AMENDMENTS TO THE DRAWINGS

Replacement Sheet
Q65519 Giovanni TRAVERSO
USSN: 09/911,625 Art Unit: 2633
Conf. No.: 3452 For: VIRTUAL
CONCATENATION OF OPTICAL...
(202) 293-7060 1/4

FIG. 1

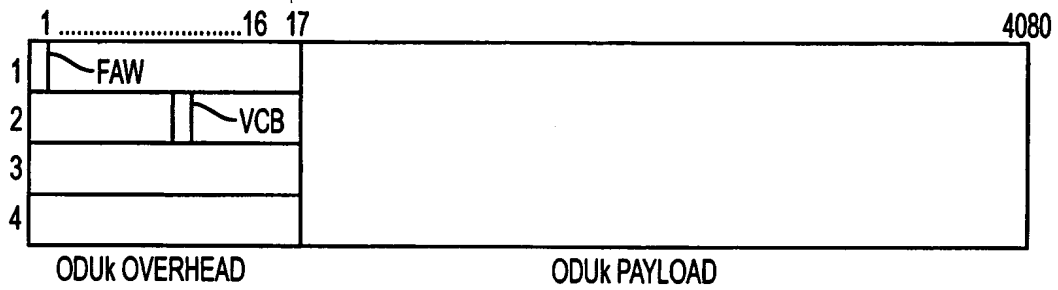
Figs. 1-3 have been amended to coincide with MPEP 608.02.

FIG. 4

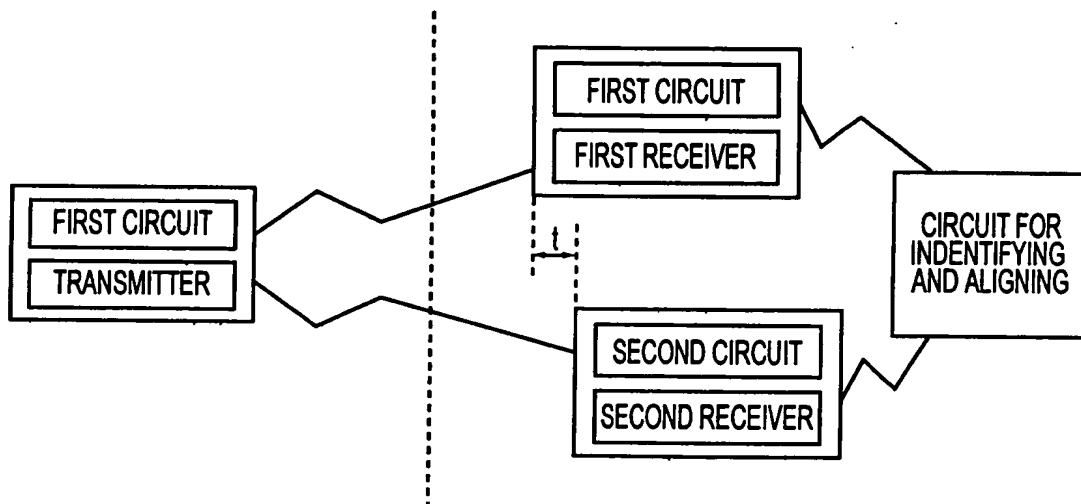
Fig. 4 has been added to illustrate the first circuit and transmitter of claim 6 and the first receiver, first circuit, second receiver, second circuit and circuit for identifying and aligning of claim 7. No new matter has been added.
